Addendum 11 – UN Regulation No. 12

Revision 4 - Amendment 5

05 series of amendments – Date of entry into force: 4 January 2023

Uniform provisions concerning the approval of vehicles with regard to the protection of the driver against the steering mechanism in the event of impact

"Annex 2

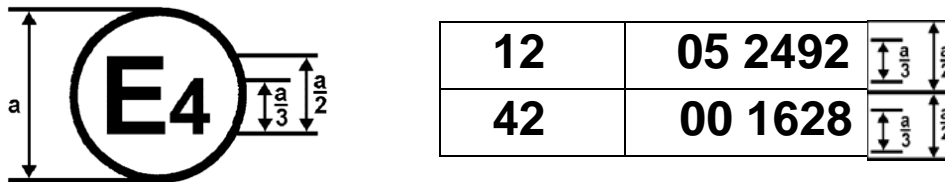
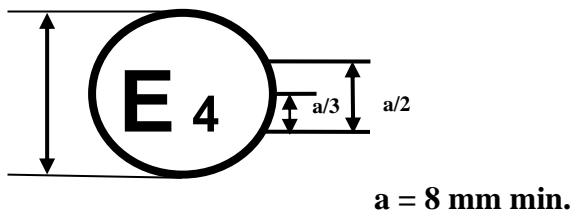
Annex 2, amend to read:

The above approval mark affixed to a vehicle shows that the vehicle type concerned has, with regard to the protection of the driver against the steering mechanism in the event of impact, been approved in the Netherlands (E4) pursuant to Regulation No. 12. The approval number indicates that the approval was granted according to the requirements of Regulation No. 12 as amended by the 05 series of amendments.

The above approval mark affixed to a vehicle shows that the vehicle type concerned has been approved in the Netherlands (E4) pursuant to Regulations Nos. 12 and 42¹. The approval numbers indicate that, at the dates when the respective approvals were given, Regulation No. 12 included the 05 series of amendments and Regulation No. 42 the 00 series of amendments.

The above approval mark affixed to a steering control shows that the steering control type concerned has, with regard to the protection of the driver against the steering mechanism in the event of impact, been approved in the Netherlands (E4) pursuant to the relevant part of Regulation No. 12 as amended by the 05 series of amendments.

The above approval mark affixed to a steering control shows that the steering control type concerned has been approved in the Netherlands (E4) with regard to the protection of the driver against the steering mechanism in the event of impact, pursuant to provisions of paragraphs 5.1.2. and/or 5.2.1. of UN Regulation No. 12 as amended by the 05 series of amendments."

Figure 3
Jointed Test Finger

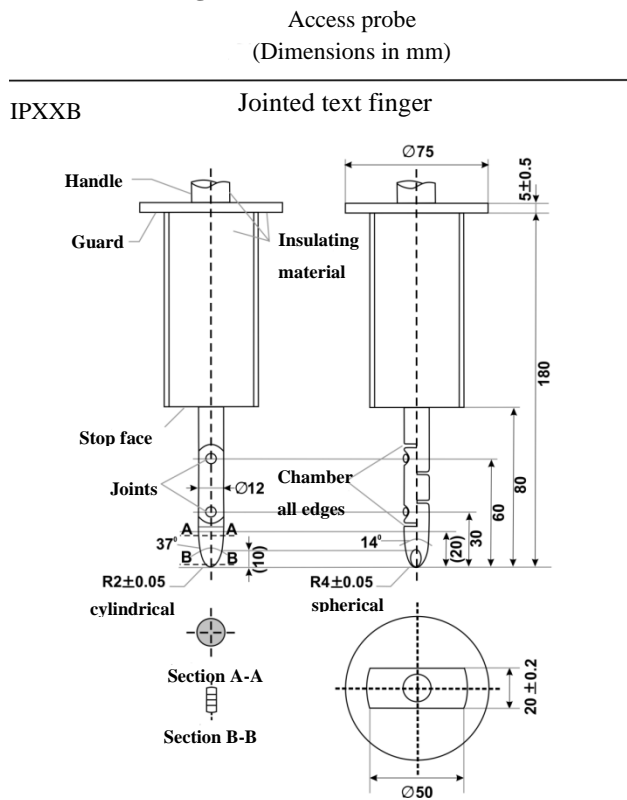
Annex 7, paragraphs 4. to 4.1., amend to read:

The jointed test finger described in Figure 3 shall be inserted into any gaps or openings of the physical protection with a test force of $10 \text{ N} \pm 10$ per cent for electrical safety assessment. If partial or full penetration into the physical protection by the jointed test finger occurs, the jointed test finger shall be placed in every position as specified below.

Starting from the straight position, both joints of the test finger shall be rotated progressively through an angle of up to 90 degrees with respect to the axis of the adjoining section of the finger and shall be placed in every possible position.

Both joints shall permit movement in the same plane and the same direction through an angle of 90° with a 0 to $+10^\circ$ tolerance.

The requirements of paragraph 5.5.1.3. of this Regulation are met if the jointed test finger described in Figure 3, is unable to contact high voltage live parts.

Figure 4

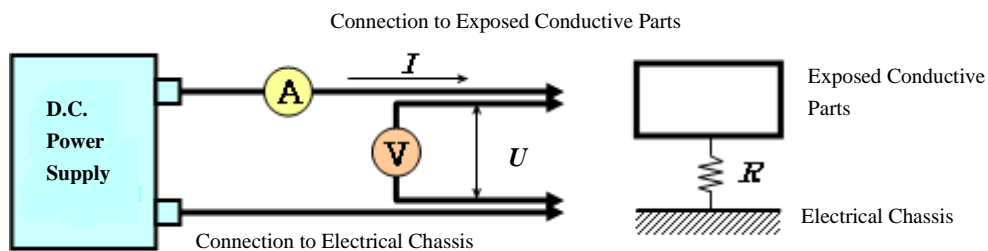
- (b) Test method using DC power supply, voltmeter and ammeter.

The DC power supply, voltmeter and ammeter are connected to the measuring points (Typically, electrical chassis and electro conductive enclosure/electrical protection barrier).

The voltage of the DC power supply is adjusted so that the current flow becomes at least 0.2 A.

The current "I" and the voltage "U" are measured.

The resistance "R" is calculated according to the following formula:

$$R = U / I$$

The resistance R shall be less than 0.1 Ω.

Note: If lead wires are used for voltage and current measurement, each lead wire shall be independently connected to the electrical protection barrier/enclosure/electrical chassis. Terminal can be common for voltage measurement and current measurement.

An example of the test method using DC power supply, voltmeter and ammeter is shown below.

Figure 5
Measurement of U_1'

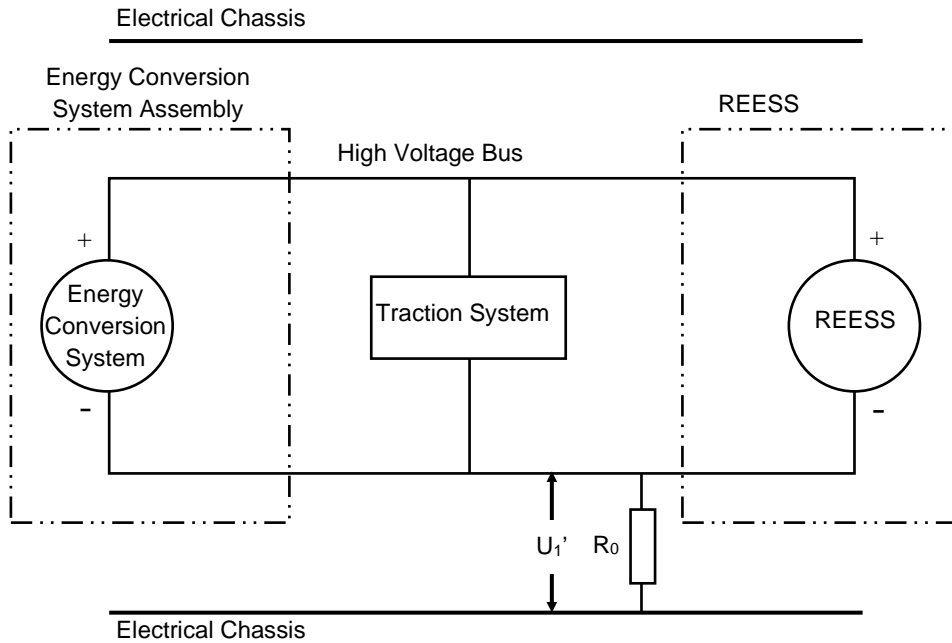
If U_1 is greater than or equal to U_2 , a standard known resistance (R_o) is inserted between the negative side of the high voltage bus and the electrical chassis. With R_o installed, the voltage (U_1') between the negative side of the high voltage bus and the electrical chassis is measured (see Figure 5).

The electrical isolation (R_i) is calculated according to the following formula:

$$R_i = R_o * U_b * (1/U_1' - 1/U_1)$$

Figure 6
 Measurement of U_2'

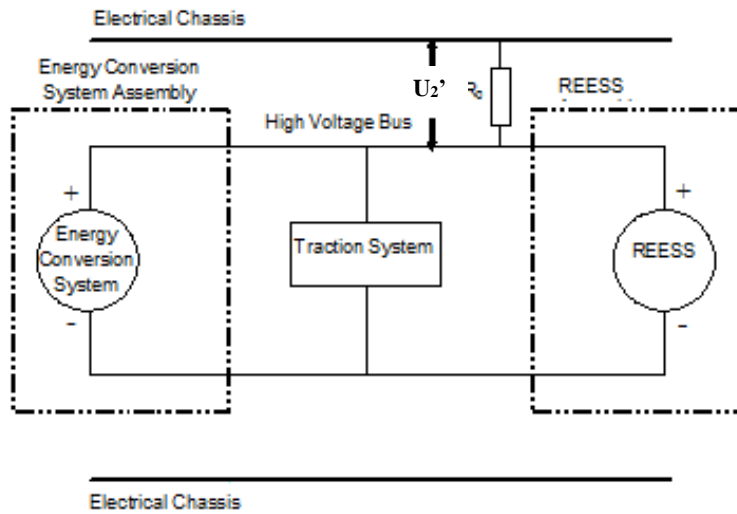
If U_2 is greater than U_1 , insert a standard known resistance (R_0) between the positive side of the high voltage bus and the electrical chassis. With R_0 installed, measure the voltage (U_2') between the positive side of the high voltage bus and the electrical chassis (see Figure 6 below). The electrical isolation (R_i) is calculated according to the following formula:

$$R_i = R_0 * U_b * (1/U_2' - 1/U_2)$$
